Item Name: Fwd Crosstube - High 407

DART AEROSPACE LTD		Work Order:	140423
Description: Crosstube High Fwd (407)		Part Number:	D407-667-105
Inspection Dwg: D407-667-145 Rev: C		Page 1 of 1

DART AEROSPACE LTD HAWKESBURY, ONTARIO, CANADA	
DRAWING NO. D407-667-145	REV. C SHEET 1 OF 4
TITLE CROSSTUBE ASS'Y (407 HIGH FWD)	SCALE NTS

DRAWING NO. D407-667-145	TITLE CROSSTUBE ASS'Y (407 HIGH FWD)	REV. C	DART AEROSPACE LTD ENGINEERING ORDER		D.E.O. NO. D407-667-145-C-1	SHEET NO. SHEET 1 OF 1	SCALE NTS
DRAWN 97	CHECKED ASS	MFG. APPR. 188	APPROVED WD		DE APPR. H		
DATE 11.07.15	DATE 11.07.22	DATE 11.07.22	DATE 11/07/22		DATE 11.07.21

DETAIL P
BONDING STRAP INSTALLATION 2 PL

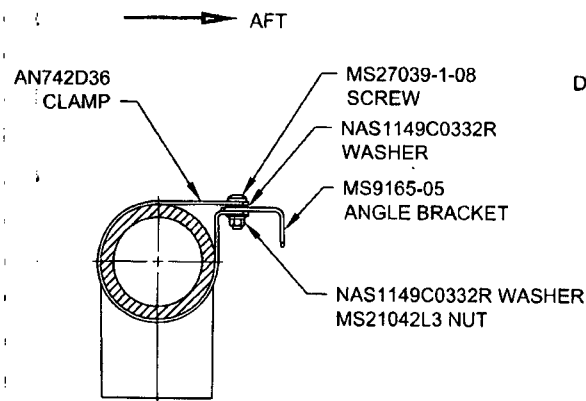
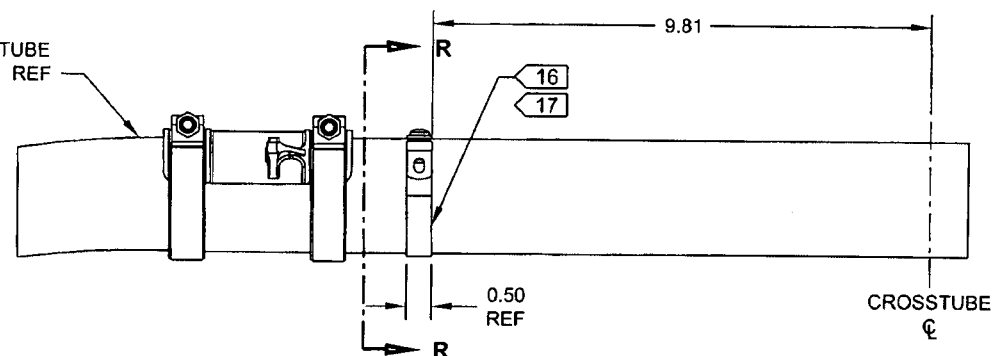
ADD ELECTRICAL GROUNDING STRAP

ITEM	QTY -145	PART NUMBER	DESCRIPTION
1	X	D407-667-145	CROSSTUBE ASSEMBLY (407 HIGH FWD)
10	2	AN742D36	CLAMP
11	2	MS9165-05	ANGLE BRACKET
12	2	MS21042L3	NUT (OR MS21042-3)
13	2	MS27039-1-08	SCREW
14	4	NAS1149C0332R	WASHER (OR AN960C10L)
